ATTACHMENT 5: *Supplementary Information re Key Project Components*

Scope of Works

View of partially removed carpet clad wall, showing fire hose reel, electrical services, and uplighting of beams

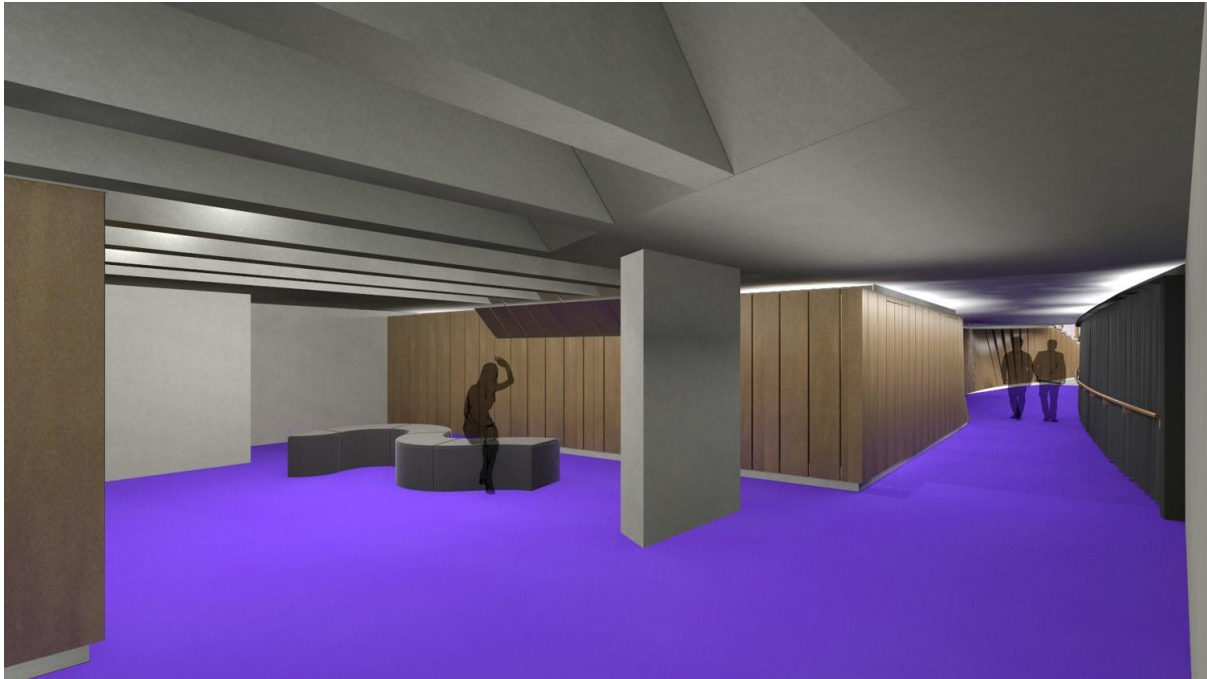
At the DAP meeting on 3 June 2019, ARM Architects presented to the DAP some findings of the review of the conditions of the south wall of the Caves. The DAP supported the further investigation of the condition of the concrete wall and the required services in this area.

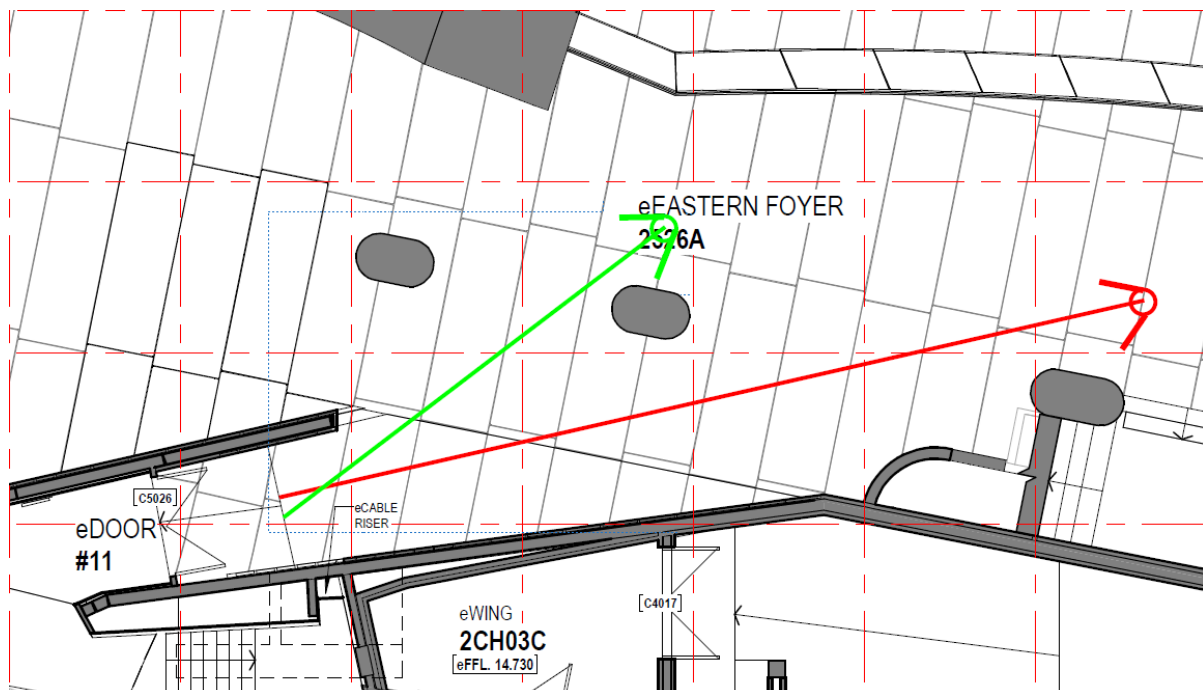
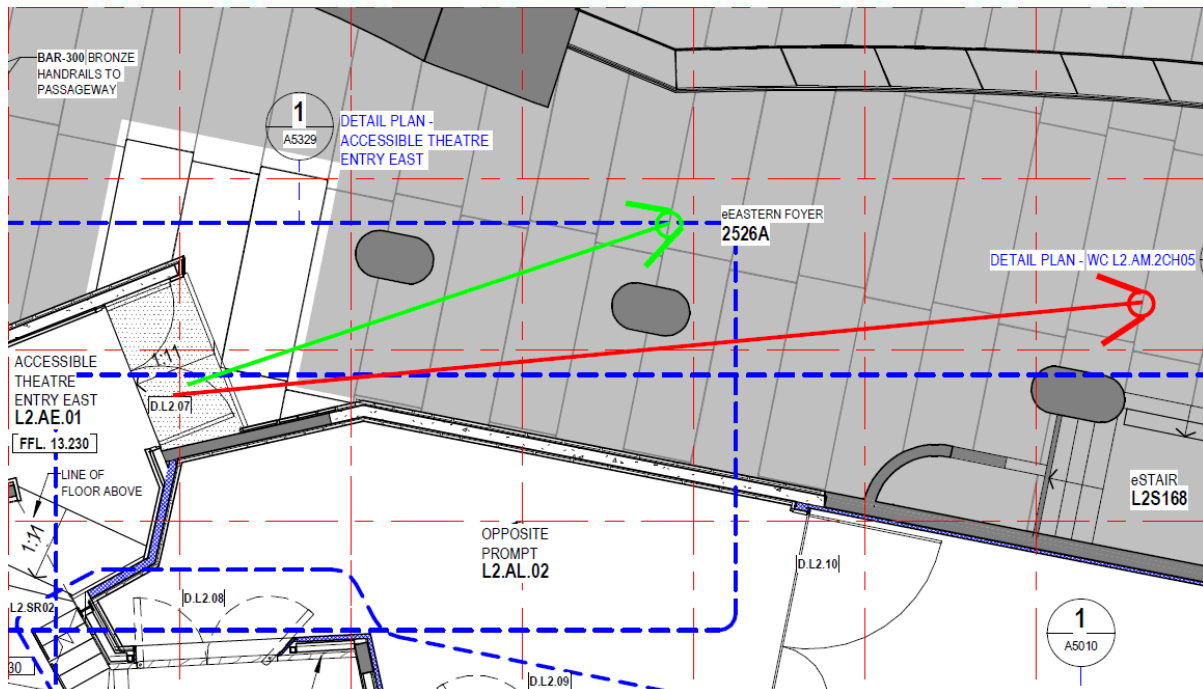
4.7 The relocated entry position to the theatre should be reconsidered to provide better visual access and orientation to patrons. Further detail of this consideration should be submitted as part of the section 60 application for the works.

As the previous submission has noted, the relocation of the entries to the side foyers is driven by the introduction of the arena risers to the stage of the Concert Hall. This change does not have an appreciable impact on the grandness of the side foyers as it all occurs under the existing low ceiling space.

We also believe that the relocated entry has acceptable visual access and provides suitable assistance in the orientation of patrons in its new condition.

The red marked position is as one approaches from the Southern Foyer and first can see the entry doors into the foyer. The second is further into the side foyer and a more likely point to orient oneself. In both positions the stalls entry can be viewed.

Again, in both positions the stalls entry can be viewed. In particular the relationship of the entry doors to the second (green) position is more immediate and will aid in the orientation of people looking to make their way into the Hall. Similarly, people who are making their way up to the Northern Foyer or northern doors into the Concert Hall are not impeded by this entry as the natural ant track to these spaces remains on the eastern side of the large columns and within the grand volume of the side foyer.
